| Company | Trenz Electronic GmbH |
| PCN Number | PCN-20221116 |
| Title | TEI0003-02 to TEI0003-03 Hardware Revision Change |
| Subject | Hardware Revision Change |

2.8 #8 Updated components from library.

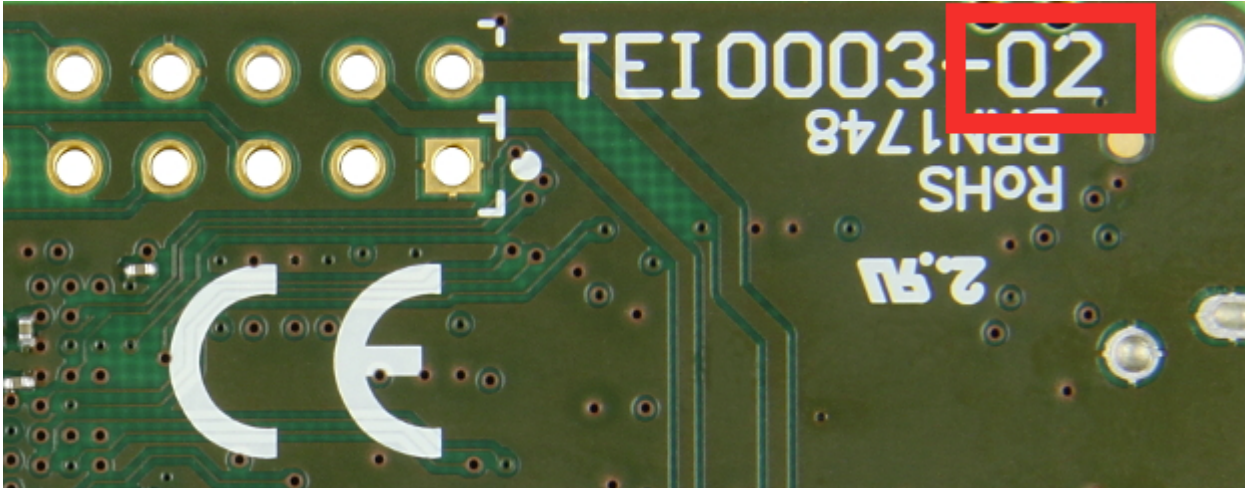
Type: Schematic Change

Reason: Use latest component data.
